Contract #: 04-0120F4Cty: SF/ALA Rte: 80 PM: 13.2/13.9File #: 69.25B**QUALITY ASSURANCE -- NON-CONFORMANCE REPORT****Location:** Changxing Island, Shanghai, P.R. China**Report No:** NCR-000989**Prime Contractor:** American Bridge/Fluor Enterprises, a JV**Date:** 12-Mar-2011**Submitting Contractor:** Zhenhua Port Machinery Company, Ltd (ZPMC), Changxing Island**NCR #:** ZPMC-0947**Type of problem:**

Reference Description: QA found a missed UT indication after ZPMC had tested and accepted the weld at Traveler Rail 20TR2-030

Job Name: SAS Superstructure
Document No: 05.03.06-000946

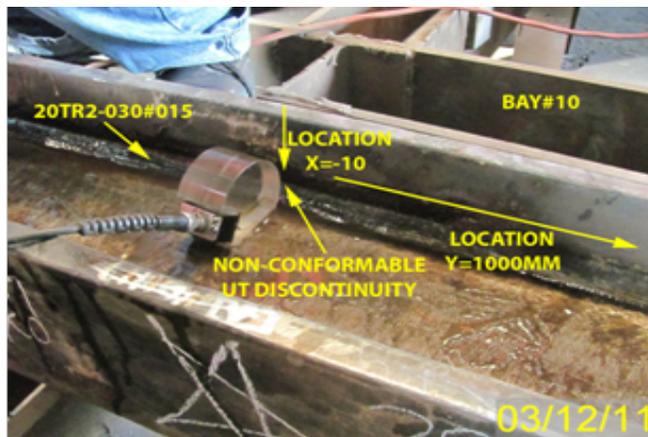
During the Quality Assurance (QA) Ultrasonic Testing (UT) verification of weld located on traveler rail 20TR2-030-015, this QA Inspector discovered the following issue:

- One (1) Class "A" non-conforming longitudinal indication in a weld.
- UT discontinuity rating was +9 dB.
- Depth of the discontinuity from face "A" is approximately 14 mm.
- Length of the discontinuity is approximately 10 mm in length.
- Y location is approximately 220 mm from left side of the joint.
- The weld is a complete joint penetration (CJP) T- joint, joining the web to flange.
- The weld is identified as 20TR2-030-015.
- The nominal thickness of the material is 20 mm.
- Component located at fabrication Bay#10.

The Notice of Witness Inspection Number (NWIT) is 08527. The indication is located inside the area that has been previously tested and accepted by ZPMC Quality Control (QC) personnel. ZPMC's QC personnel performed 100% UT inspection of this weld.

ZPMC has repaired the indication noted in the NCR and is providing NDT documentation after the repair to show the indication has been removed.

ABFJV has noted which inspector was responsible for this missed indication and is monitoring his performance, if he continues to miss indications disciplinary action will be undertaken. Based on these actions, ZPMC requests closure of this NCR.

This proposed resolution is acceptable. The documentation received is sufficient and the Department concurs that Non-Conformance ZPMC-0947 is closed.

Joint fit-up Coating Other Component: Traveler Rail 20TR2-039

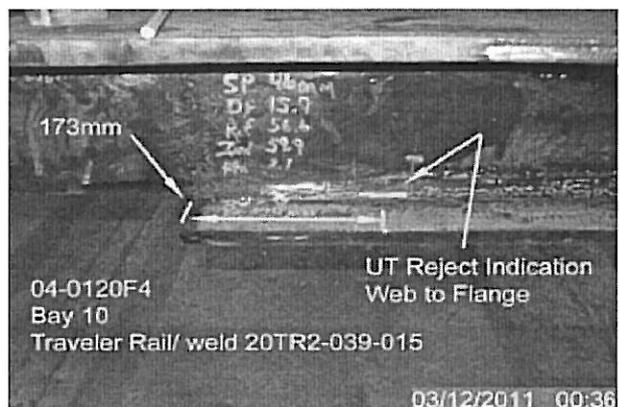
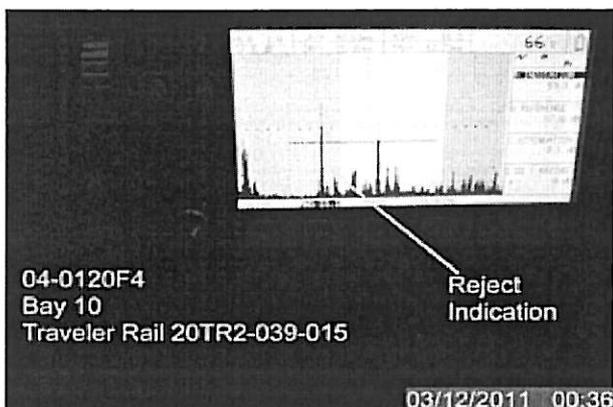
During the Quality Assurance (QA) Ultrasonic Testing (UT) verification of weld located on traveler rail 20TR2-039-015, this QA Inspector discovered the following issue:

- One (1) Class "A" indication measuring approximately 25mm in length.
- The Indication rating is +0dB.
- The thickness of the plate is 20mm and depth of the indication approximately 15.9mm.
- The indication is located on the weld joint identified as 20TR2-039-015.
- The "Y" location for this indication is approximately 173mm from weld termination point.
- The weld is a Complete Joint Penetration (CJP) T-Joint joining web to flange
- The indication is clearly marked by QA on/near the weld.
- Traveler Rail is located inside bay 10.
- The Notice of Witness Inspection Number (NWIT) is 08518. The indication is located within the area that has been previously tested and accepted by ZPMC Quality Control (QC) personnel. As per the contract documents, ZPMC's QC personnel are required to perform 100% UT inspection of this weld.

ZPMC acknowledged these two problems and has issued two internal NCRs. ZPMC has repaired the indications noted in the NCRs and is providing WR & NDT documentation after the repair to show the indications have been removed. Based on these actions, ZPMC requests closure of these two NCR.

焊缝编号为： 20TR2-030-015,20TR2-039-015

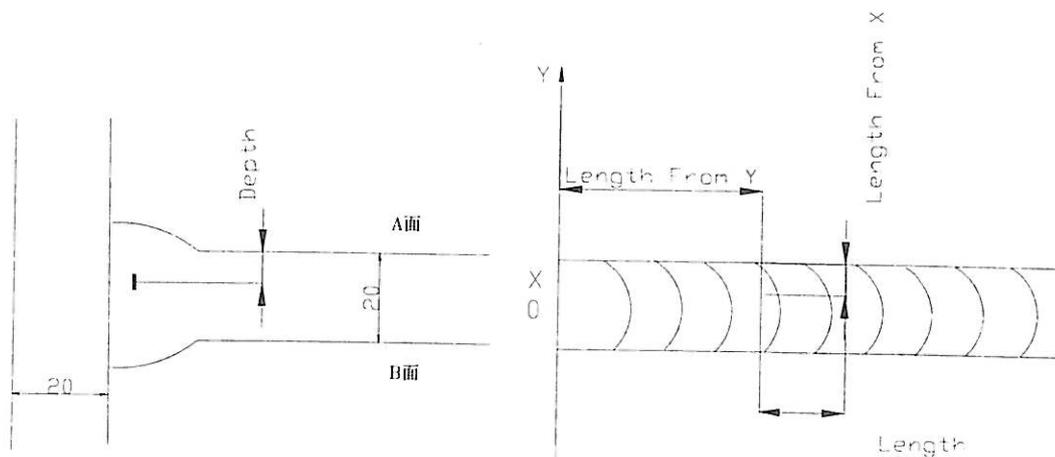
(Description of welding discontinuity): Rejected indication found by ultrasonic inspection is less than the maximum allowance aggregate length.

1. Did not clear the weld pass completely in time.

1. Gouge or grind from nearer side from metal edge ($D \leq 0.65T$, "D" is depth of defects, "T" is thickness of metal) to remove all defects;
2. Follow repair WPS for joint preparation, preheat, and weld deposit;
3. Grind the repaired area flush with base metal or the adjacent weld;
4. Check the welds according to the working drawings.

1. Improve monitoring of welding and interpass cleaning.
